SERVICE BULLETIN

APPLICABILITY: 2015-2016MY Legacy and Outback
 2015-2016MY Impreza and XV Crosstrek
 2016MY Forester
 2016MY WRX

NUMBER: 15-198-16R
DATE: 05/02/16
REVISED: 06/22/16

SUBJECT: Reprogramming File Availability to Address Operational Concerns with “Gen 2” Fujitsu-TEN (F10) Navigation and 7” Display Audio Units

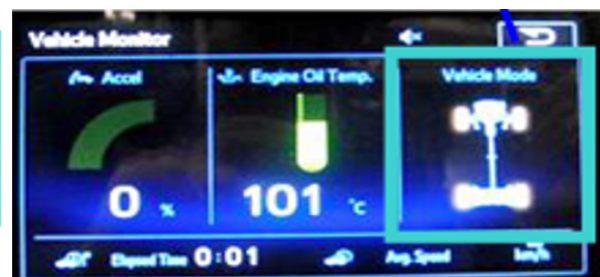
- Logic change to provide a “_” (underscore) character on the keyboard.
- Logic change to match the engine oil maintenance remaining mileage on the maintenance reminder screen to the odometer meter value on the combination meter when mileage unit is set to read in “KM”.
- Logic change to insure the Vehicle Mode indicator on the Vehicle Monitor screen matches the actual vehicle status. Example: The wheel indicators on the vehicle monitor screen no longer stay illuminated indicating VDC is “active” after VDC activation is complete.
